May 20, 2021

**RE: 355 FIRST STREET**

I reviewed the drawings and evaluated the site context. My comments and suggestions are as follows:

**ILLUSTRATIVE ELEVATION RECOMMENDATION**

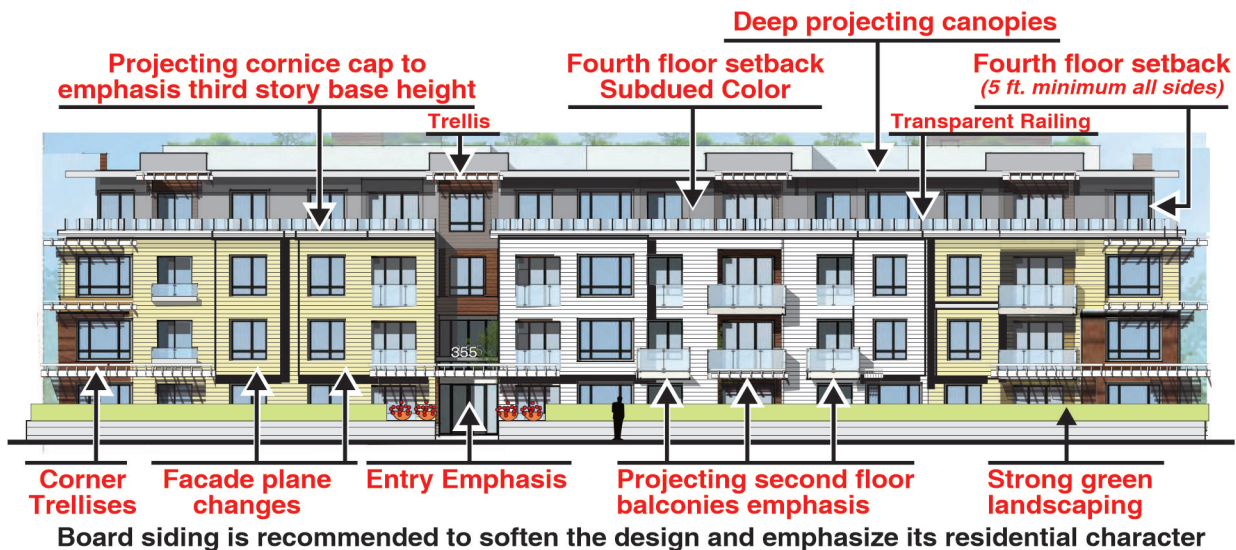
The illustrative First Street elevation shown below is one way to incorporate the design goals into future design modifications. Other approaches that adhere to the design goals are, of course, possible, and design refinements to the elevation shown would be expected in any case. The basic floor plans, floor heights and windows have not been changed in the illustrative recommendations to minimize potential conflicts with the building's functioning, and to allow an apples-to-apples comparison. When I review the design of challenging developments like this one, I first identify the issues, and then look through the thousands of project examples in my files to find ones where similar conditions have been successfully addressed. In this review, the recommended approach draws heavily from projects which have successfully applied building forms and details to reduce visual mass and height while adding details that would be complementary to the community's expectation of a project design with Village Scale and Character as a primary goal.

1. Strong ground floor focus on the pedestrian experience and first floor residential units livability.
2. Small scale architectural detail at the second floor level to stress pedestrian scale and strengthen residential character with balcony activity close to pedestrian level.
3. Entry emphasis with architectural detail and landscaping.
4. Significant setback of fourth floor, and muted color and detailing to visually subordinate the upper floor.
5. Building corner architectural detailing.
6. Break up of large building facades with color, facade and/or material changes.
7. Facade articulation through recessed windows and balconies.

RECOMMENDED FIRST STREET ELEVATION

## GARAGE ENTRIES

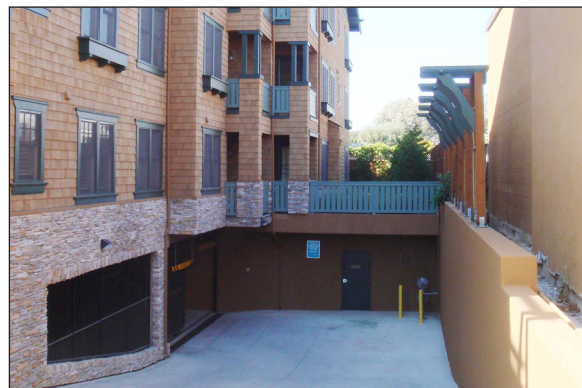
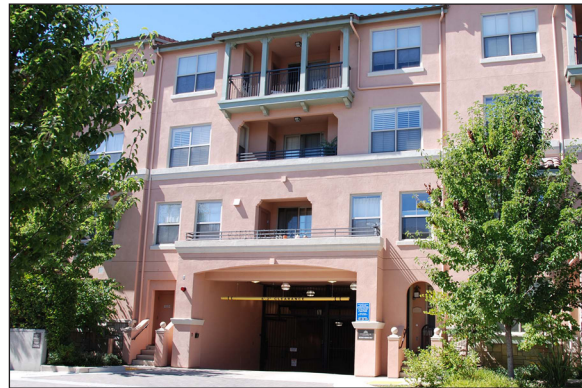
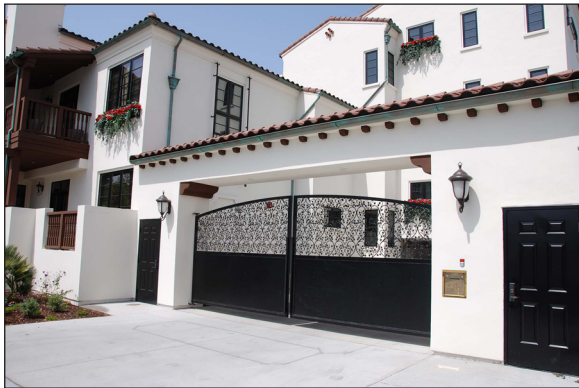
The currently proposed facades related to the garage entry would benefit from some additional design attention - see facade segments below.

Designing the garage entry to better integrate it into the overall building facade would result in its blending into the design rather than standing out as a focal point. A couple of examples are shown below that are integral to the overall design,

**INTERIOR COURTYARD ATRIUM**

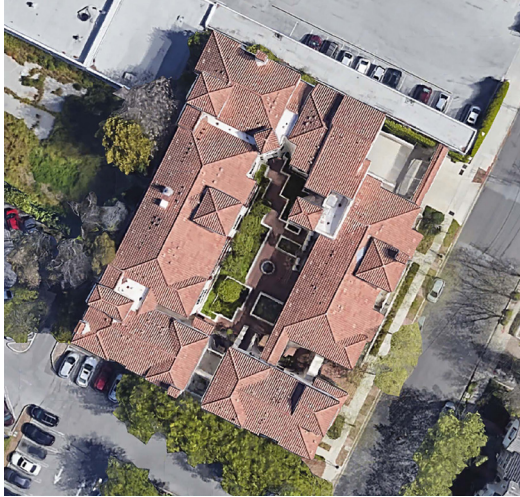
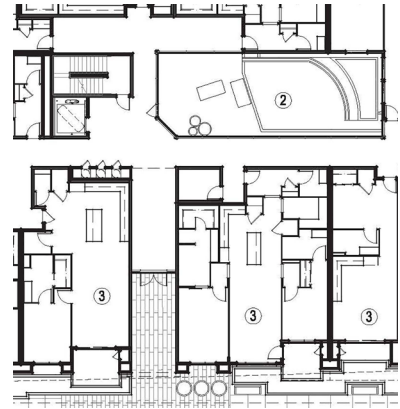
The proposed entry courtyard atrium seems like a lost opportunity. It appears to be surrounded by glazing at the first floors and all floors above grade.

There may be some special code provisions that are driving this design, but I've seen other open air atria in multifamily housing that seem more human and visually pleasant.
